Office for
Nuclear Regulation

**Return to service safety case for Reactor 4 following core inspection results in 2018
(NP/SC 7785),
Graphite structural integrity assessment**

Assessment Report ONR-OFD-AR-19-007
Revision 1
August 2019

Figure 13: Correlation of peak DUs to keying system failures.
 (Reproduced from Reference 37)

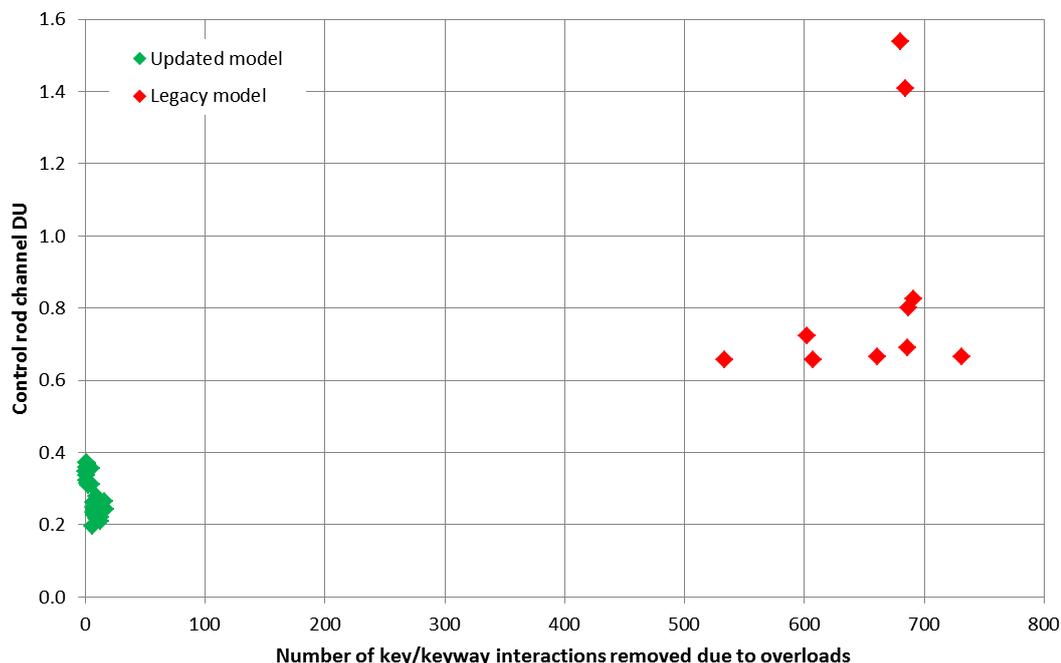
207 NGL claims the cause of the much reduced channel distortions (comparing Figure 11 and 12 with Figure 9) is due to the reduced seismic input causing far fewer failures in the keying system, illustrated by Figure 13 below.

208 It is not surprising that the peak channel distortions would be reduced for such a significant reduction in the severity of the seismic input to the graphite core (Figure 10). However, I accept that fewer removals of key/keyway interactions will also reduce peak channel distortions by maintaining the intended constraints on brick movement and also preventing the kinds of localised failures I have described above in paragraph 201.

Figure 14: Effect of the updated model property bounds on channel distortion.
(Figure taken from Reference 75)

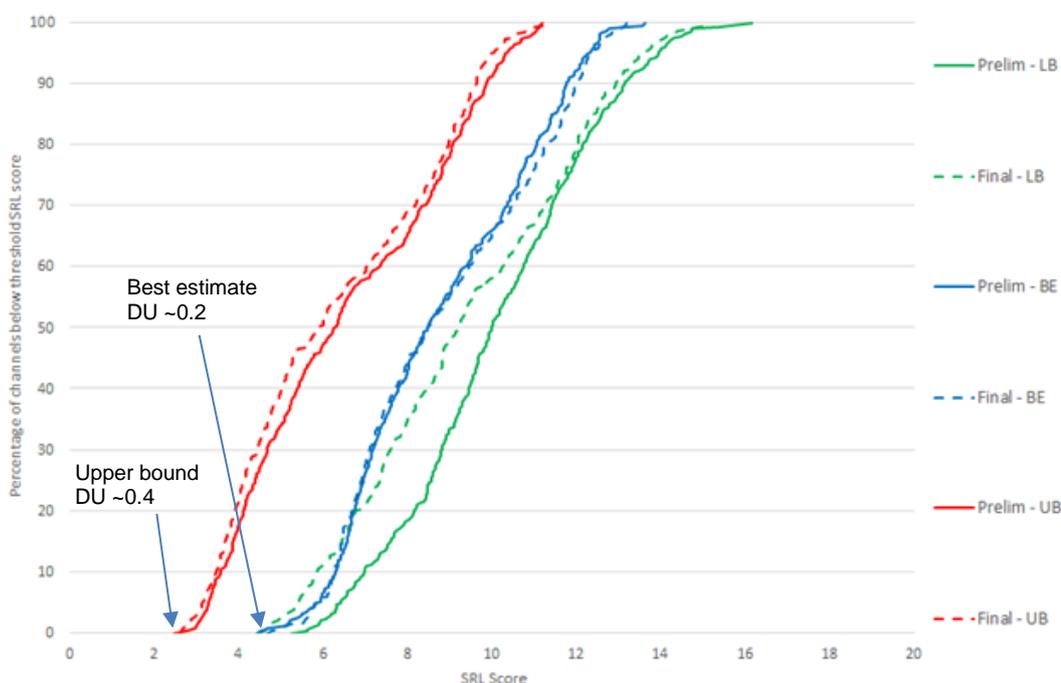
- 228 In the same way as m3dsf, the SRL value can be inverted so that it describes an approximate DU, I have indicated in Figure 14 the approximate peak DU value for the best estimate and upper bound cases, i.e. ~0.2 and ~0.4 respectively. For reference, the crack configuration of the upper bound and best estimate cases is consistent with the 'sensor rod' results presented in Figure 11 at 400 DCBs.

- 229 The sensitivity study shows the use of upper bound properties in the updated PCPV model effectively doubles the peak distortion, but this may be an underestimate. Usual practice by the damage tolerance assessment is to evaluate multiple crack configurations to explore the uncertainty associated with the variations caused by the distribution of cracking, but Figure 14 presents only a single crack configuration. In other words the approximate DU values of 0.2 and 0.4 that I have indicated in Figure 14 are not definitive; there is scope for those values to be larger or smaller by some amount due to variations that may be caused by different crack configurations. Inspecting Figures 11 and 12 suggests that variation could change the DU by up to 0.1 if the upper bound case was to be passed through NGL's current damage tolerance

Figure 15: Illustration of an AGR fuel element.

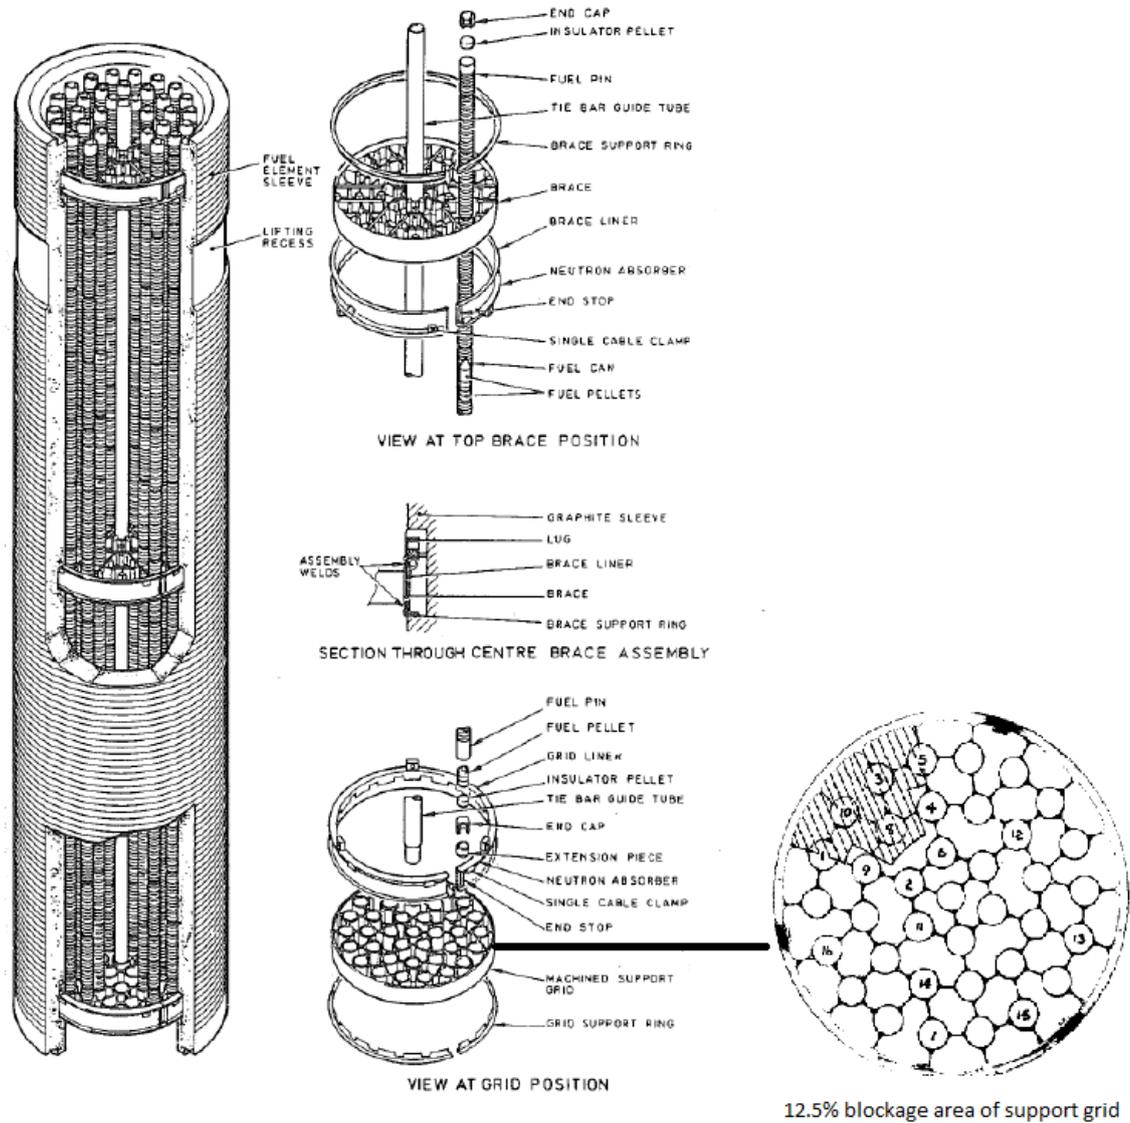
247 Debris which is large enough to be prevented from entering the fuel elements by element 1 grid but small enough to have reached element 1 grid may lead to partial blockage of the coolant flow at that location. NGL argues that the likelihood of significant blockage is acceptably low. Figure 15 provides an illustration of the fuel element and grid.

Figure 16: Illustrative flow paths at the base of the fuel channel for HPB/HNB.
(Figure taken from Reference 84)

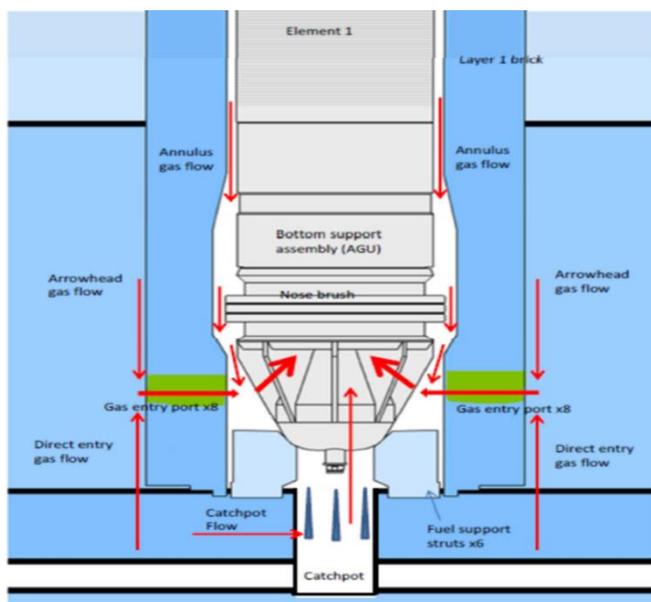
- 251 In its justification, NGL has outlined the potential paths for debris to reach the bottom of the fuel stringer where the coolant flow enters the fuel stringer. These paths are either downwards through the annulus when fuel is present, downwards through the fuel channel during fuel handling or downwards through the arrowhead passages and through the gas entry ports in brick layer 1, see Figure 16. Each path has a degree of tortuosity dictating the maximum size of debris that could feasibly travel along its path in one piece. However, the debris would be aided by a substantial gas flow of ~18m/s.

- 252 At the bottom of the fuel stringer is the Anti-Gapping Unit (AGU) through which gas flows before entering the first fuel element through the element 1 grid at the top of the AGU (Figure 16). The AGU features 8 support fins at its bottom (adjacent to the gas entry ports in Figure 16), above those fins and just before the element 1 support grid is a further set of 6 support fins. The spacing of these fins limits the credible size of debris that can access the surface of the element 1 grid.
